PLANNING COMMISSION
SITE PLAN VARIANCE REQUEST REVIEW SHEET

CASE NUMBER: SP-2013-0466DS

PROJECT NAME: 5205 S. Scout Island Circle (Boat Dock)

SUBJECT: 5205 S. Scout Island Circle, SP-2013-0466DS

5205 S. SCOUT ISLAND CIRCLE
DOCK PLAN & ELEVATIONS

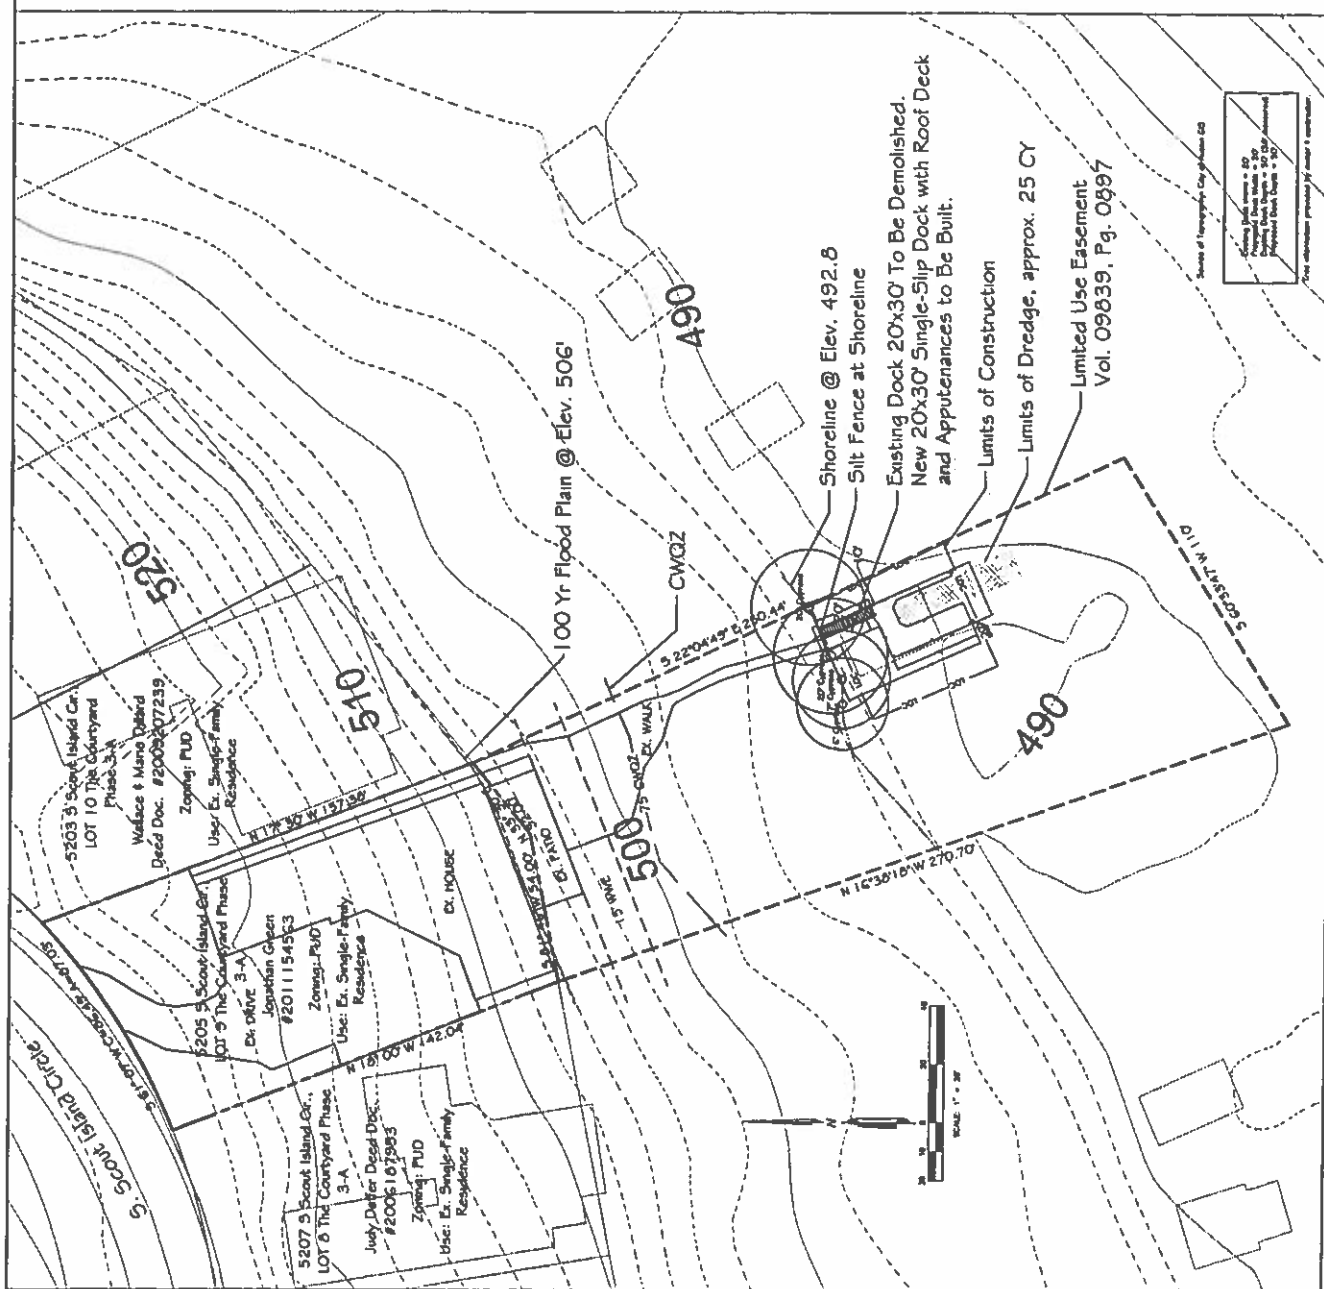
VARIANCE REQUEST: 1) To allow the proposed dock to extend more than 30 feet from the shoreline [LDC Section 25-2-1176(B)(2)], and 2) to approve dredging to accommodate watercraft access to the proposed boat dock [LDC Section 25-8-652(C)].

the navigable channel of the West Bull Creek branch is along the opposite side of the lake in the area of the proposed dock, navigation by boats and other watercraft should not be impacted by the additional dock extension into Lake Austin. The additional length will also minimize the amount of dredging required for watercraft ingress and egress to the dock.

STAFF RECOMMENDATION: These variances are recommended. Because
